28 September 2023

Megan Barr
Consultant Resource Consents Planner
Kapiti Coast District Council

RM230036- Response to Section 92 Request for 126-130 Rosetta Road

LONG SECTION C - C
A1: 1:50 A3: 1:100

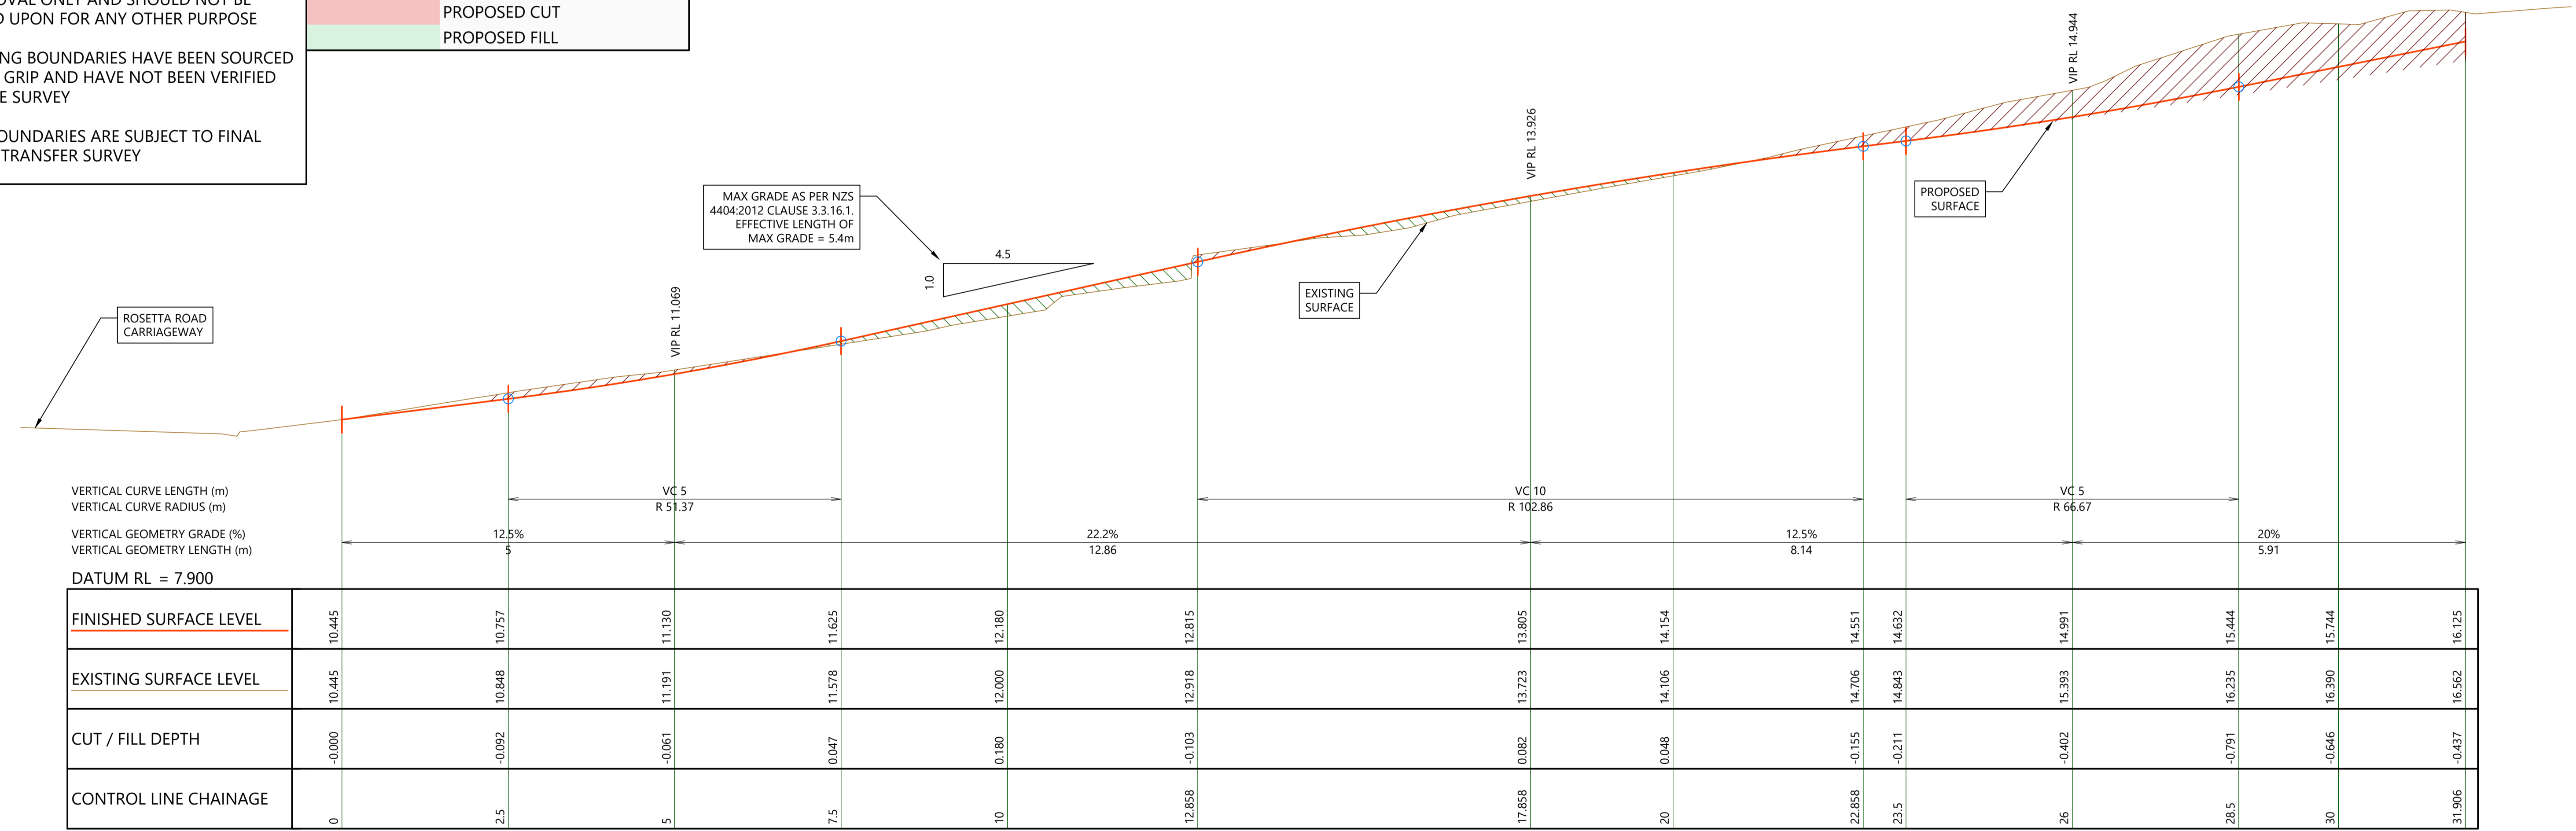
11. **Gradient of right of way.** Please refer to the Long Section at **attachment 6** which confirms the gradient will not exceed 1 in 5.
 12. **Dimensions of car parking spaces for existing dwelling.** The architectural plans have been updated at **attachment 9** to show there is sufficient room for two car parking spaces side by side. A 99th percentile vehicle has been used to show there is sufficient room.

TITLE: SCHEME PLAN - SERVICES

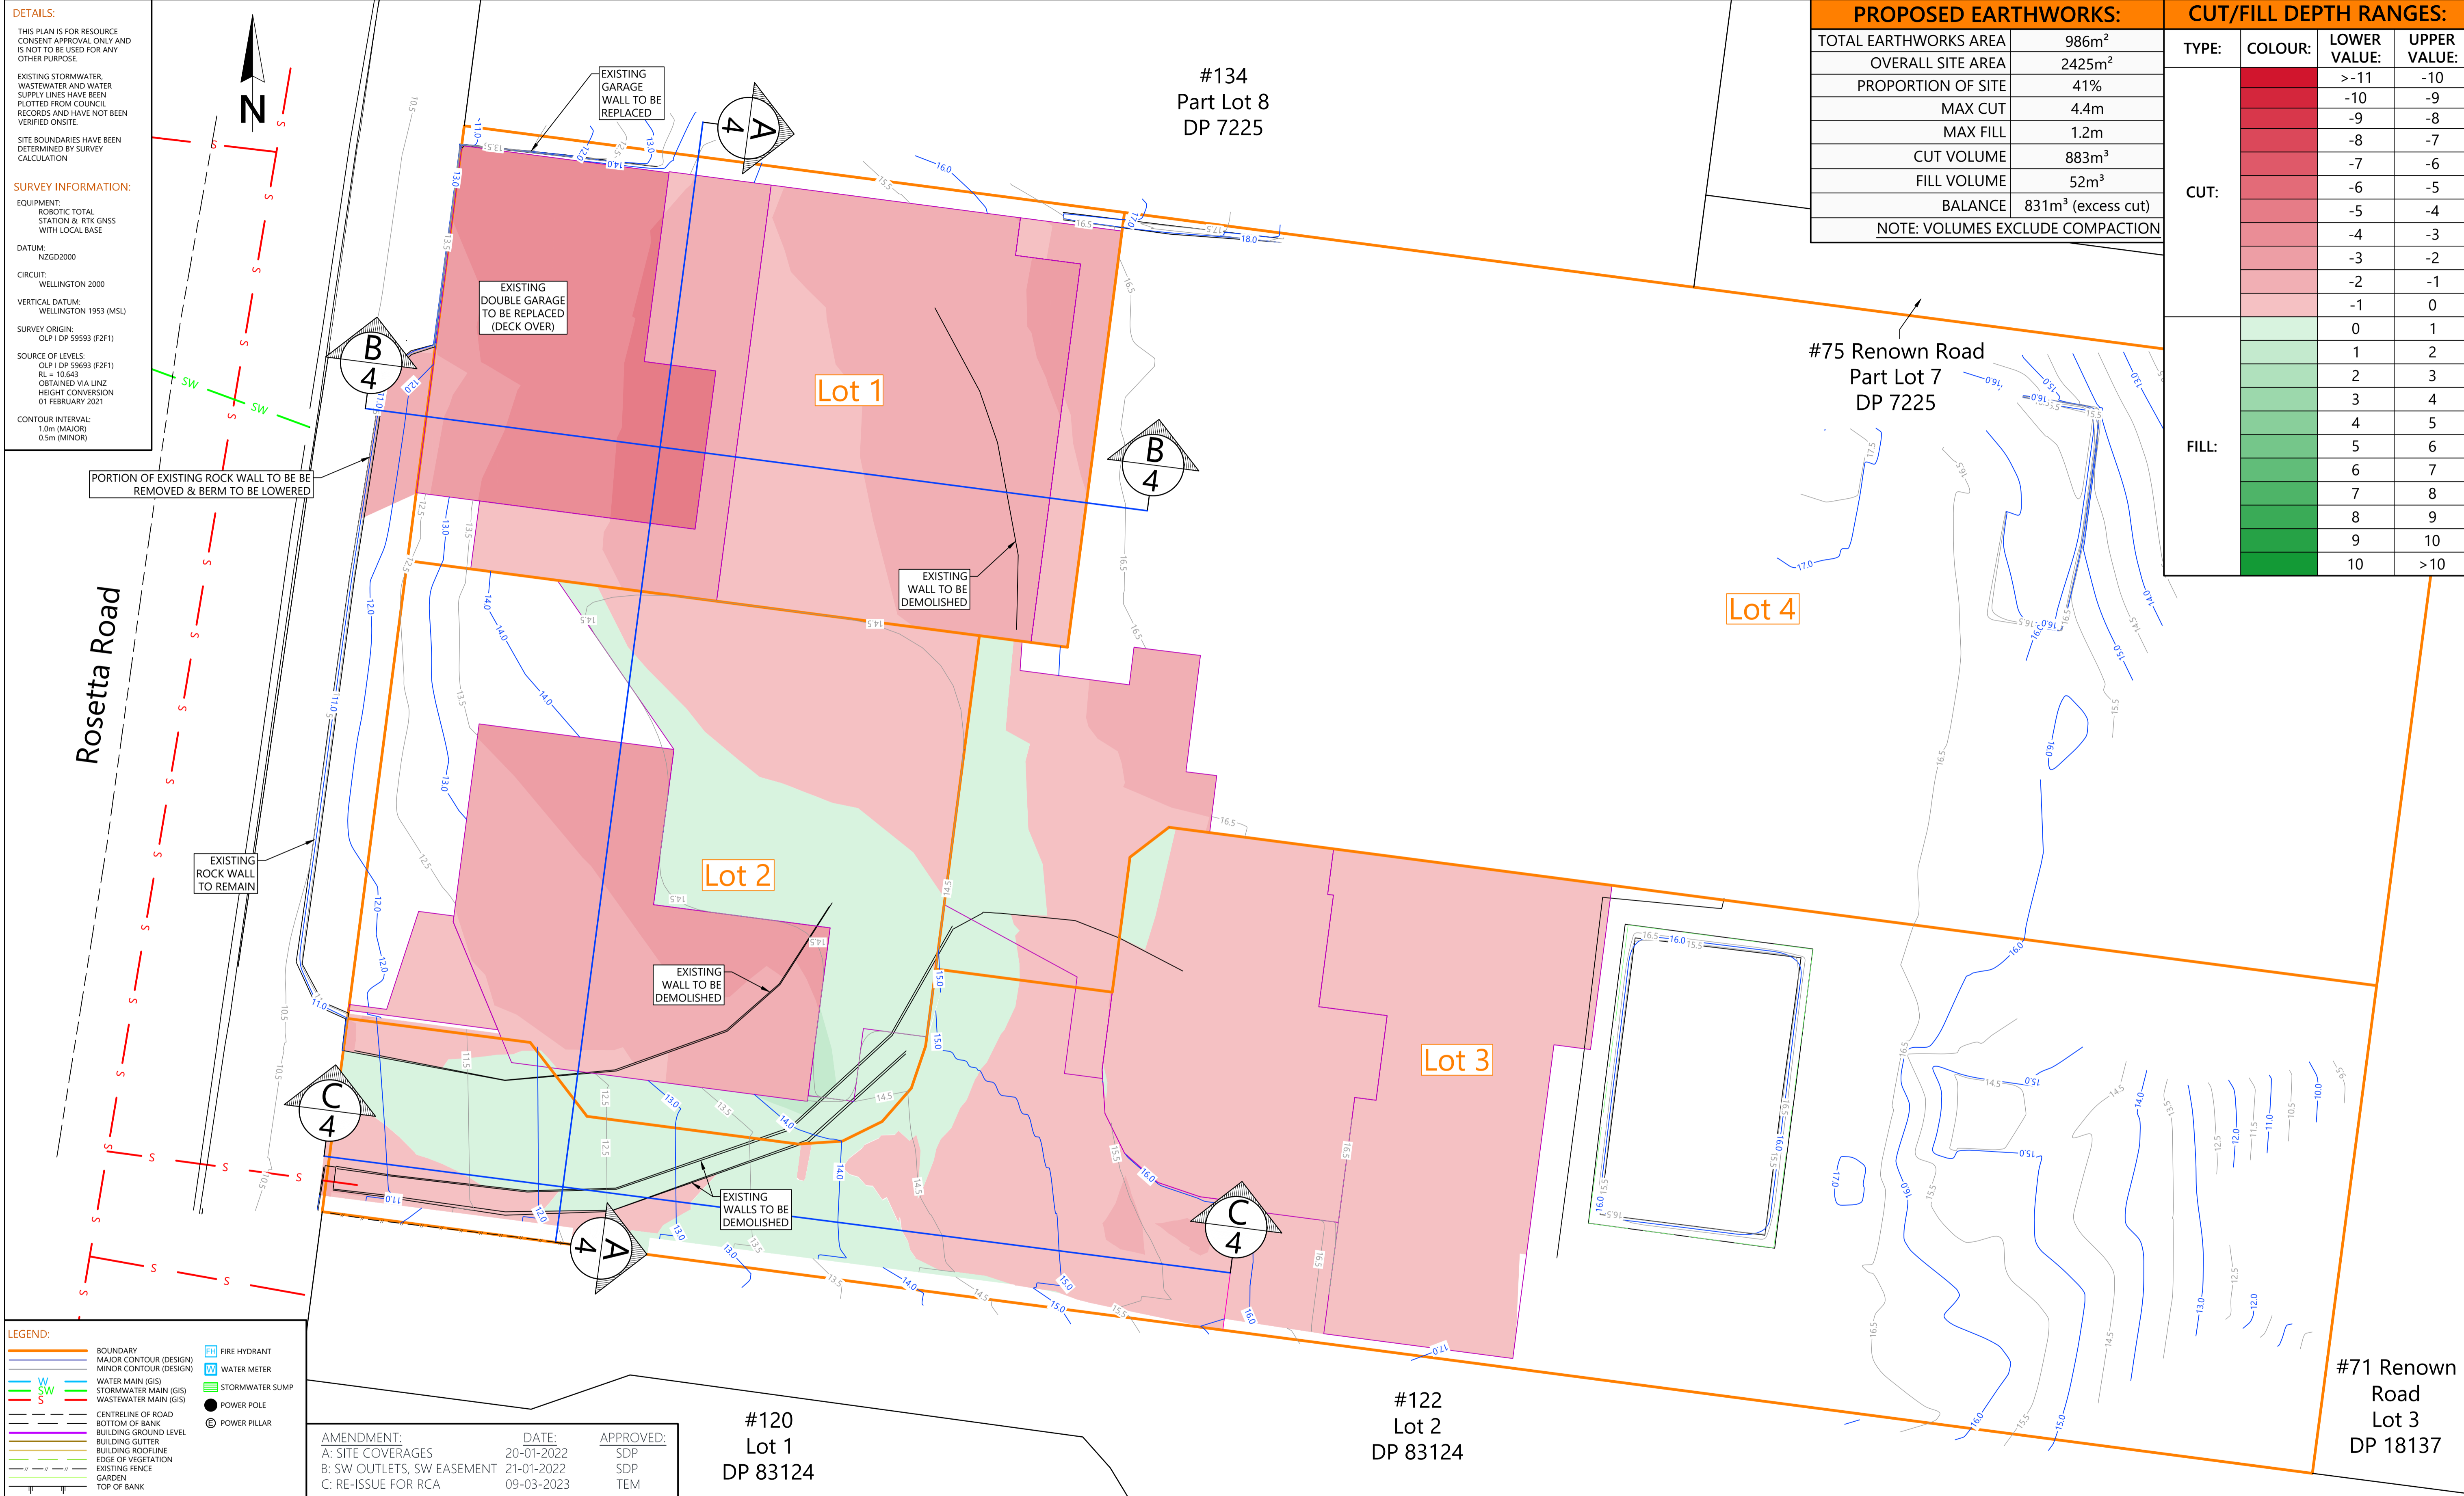
8. **Soakage Test for Lot 3.** Please refer to the peer reviewed Stormwater Report provided at **attachment 4**.
 9. **Soakpits for Lot 3 and 4.** These are shown on sheet #2 of the updated scheme plan set at **attachment 7**.
